FIELD SERVICE ACTION						
To:	All North American Dealers	Reference:				
For the attention of:	The Service Manager	FSA: 0144				
Please copy to:	The Dealer Principal					
	The Parts Manager					
	Aston Martin Technician(s)	Issued: June				
Model:	DB9 and V8 Vantage	2006				
Vin Range:	DB9 00001 to 05265, V8 Vantage see list					
Subject:	Body System Diagnostic Socket Cover	Page: 1 of 3

Diagnostic connector located in this area

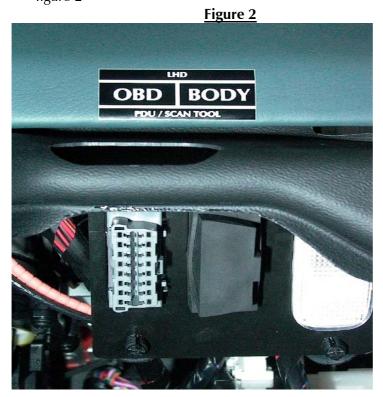
• Locate the Body system diagnostic connector as indicated in figure 1 (the body system diagnostic connector is the connector positioned closest to the centre console)

- Trim the rubber tail from the new diagnostic socket cover
- Place the diagnostic socket cover over the Body system diagnostic socket as indicated in figure 2
